Subject: Request for Proposal 2 - Changes to Backfill at Interior Retaining Walls

Project Name: Camden Rockport Middle School

Potential Change Order #007

Request for Proposal No. 002

3 1'-6" REINF CONC RETAINING WALL SECTION AT EAST GYM WALL
 SB505 SCALE: 3/4" = 1'-0"

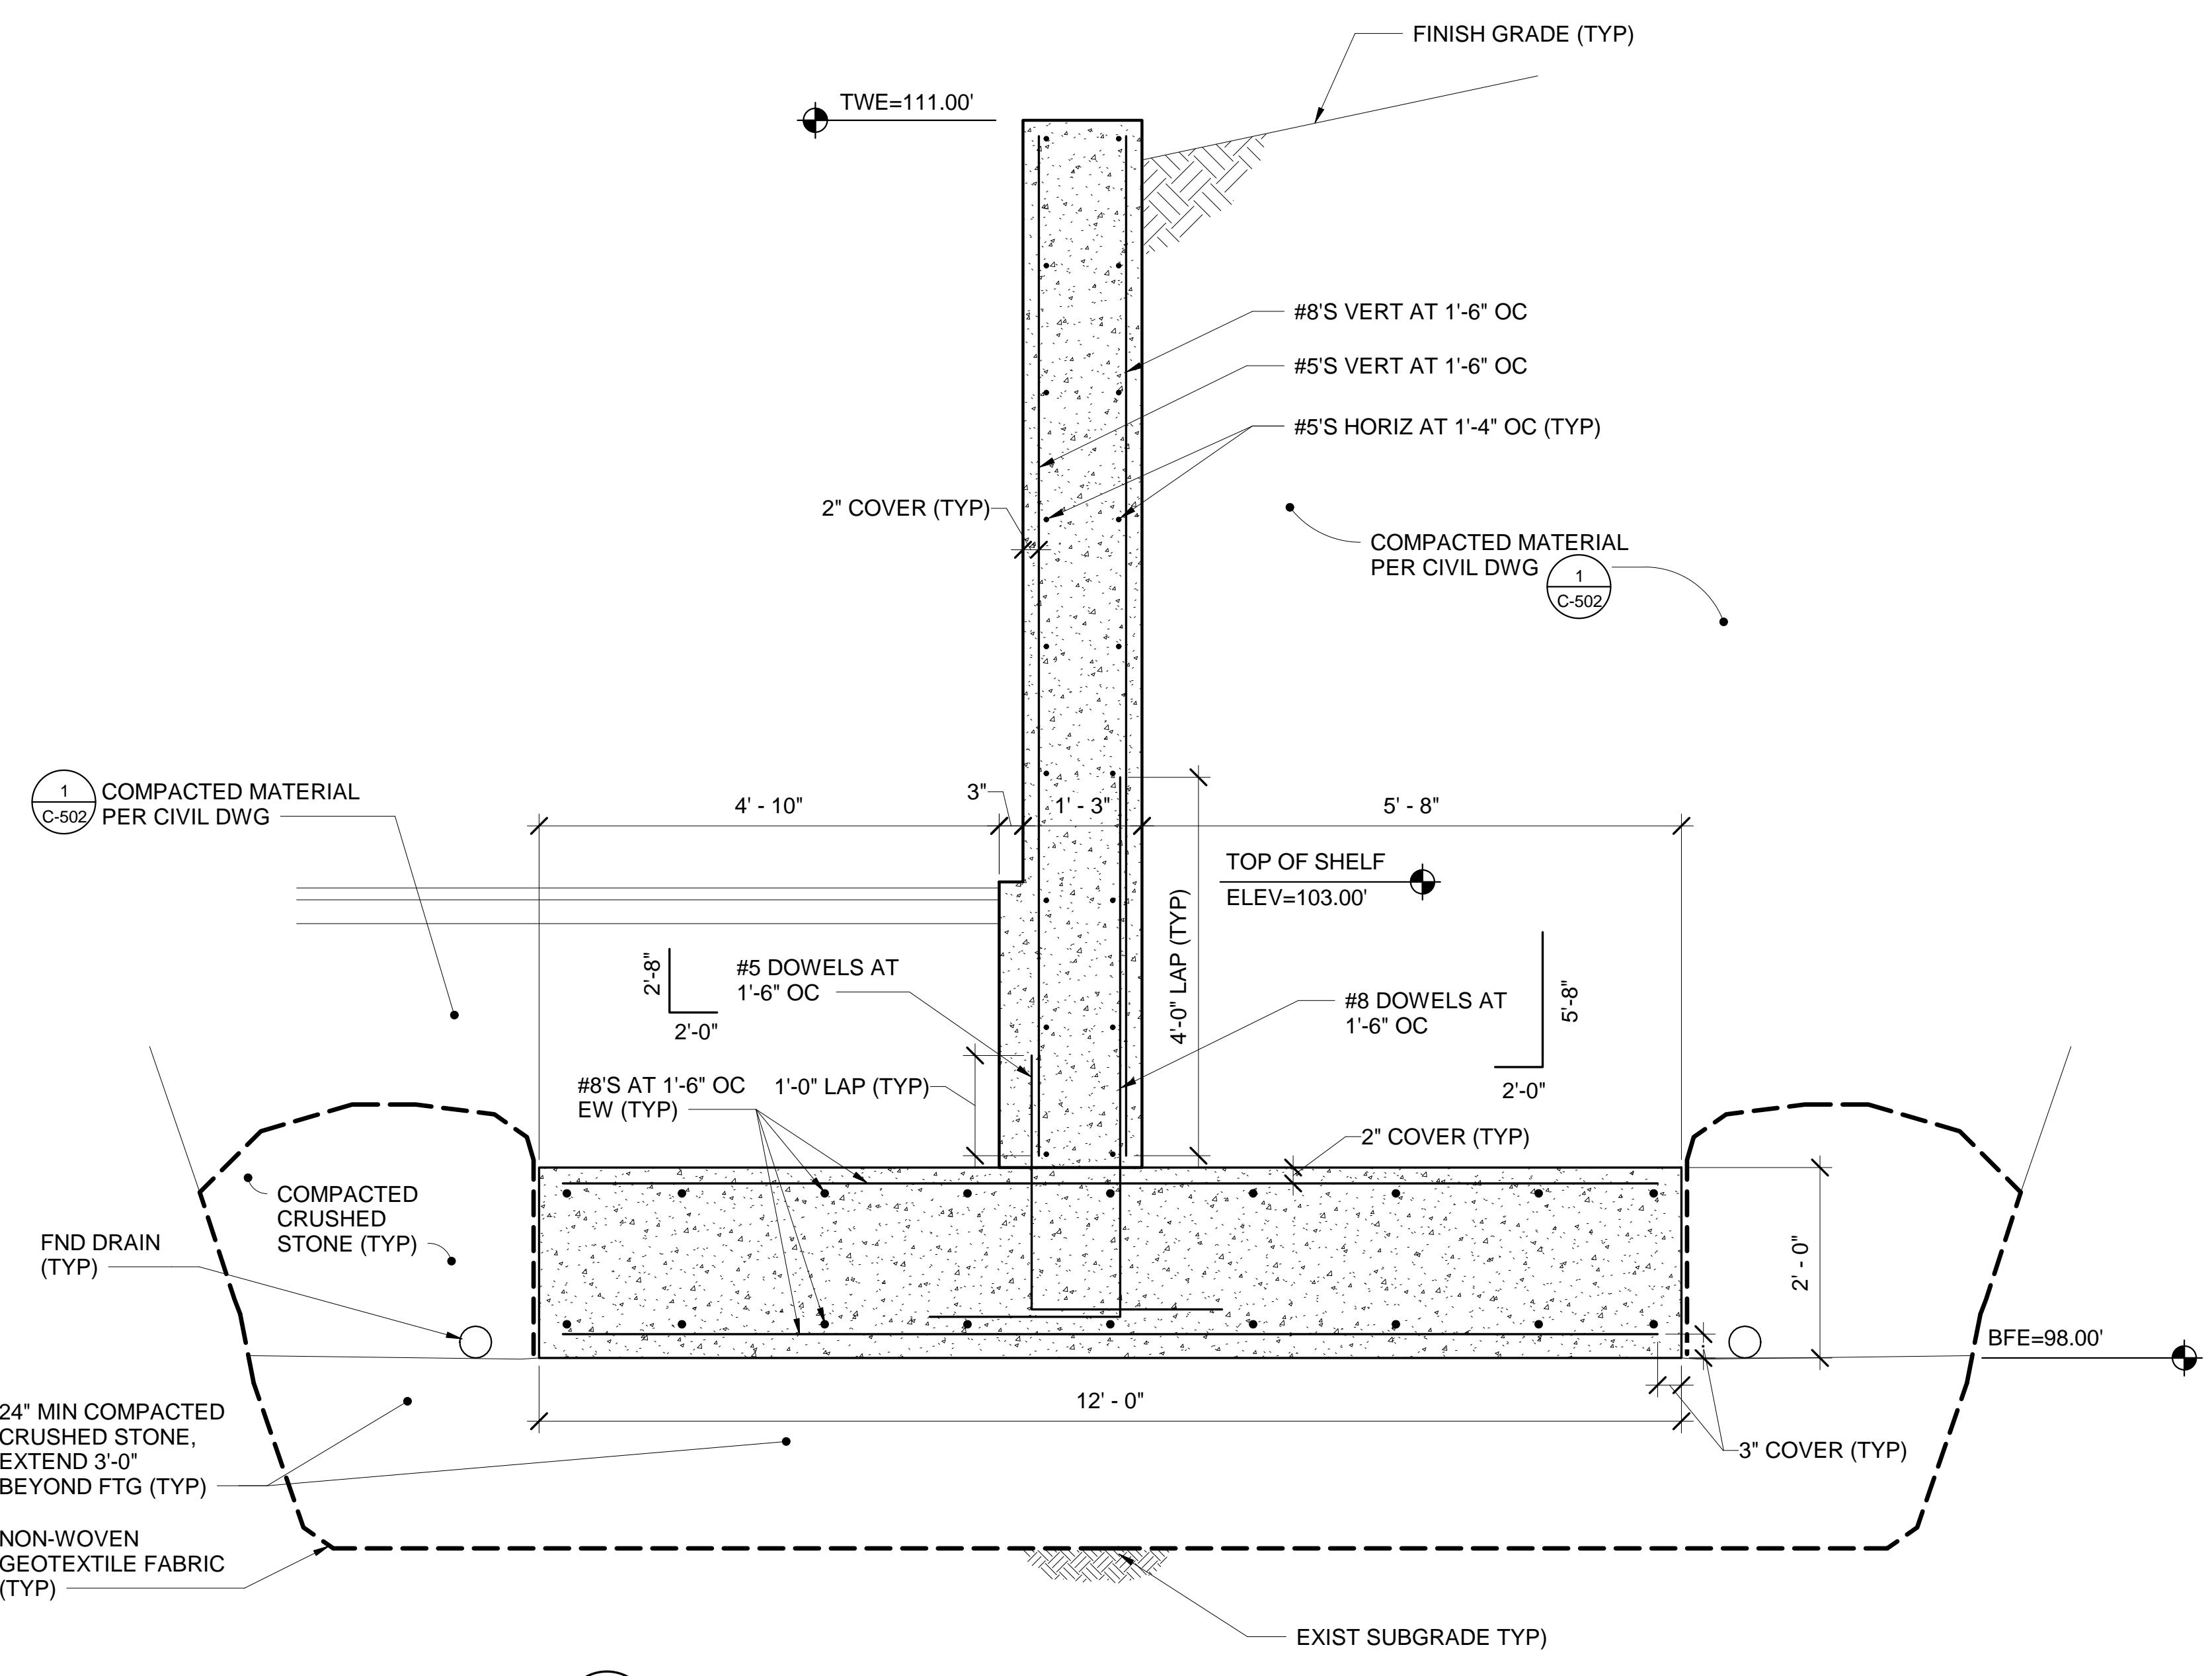
Gym Wall: There is no change to footing and wall forming square footage so costs remain the same.
Reducing the width of the footing will require cutting the reinforcing steel that has been supplied.

3. Revise reinforced concrete retaining wall indicated in detail 1/SB504.
4. Refer to attached drawings SB102 (**Revised 08-22-18**), SB503, SB503, SB504 and SB505 for modifications to foundation plans and details.
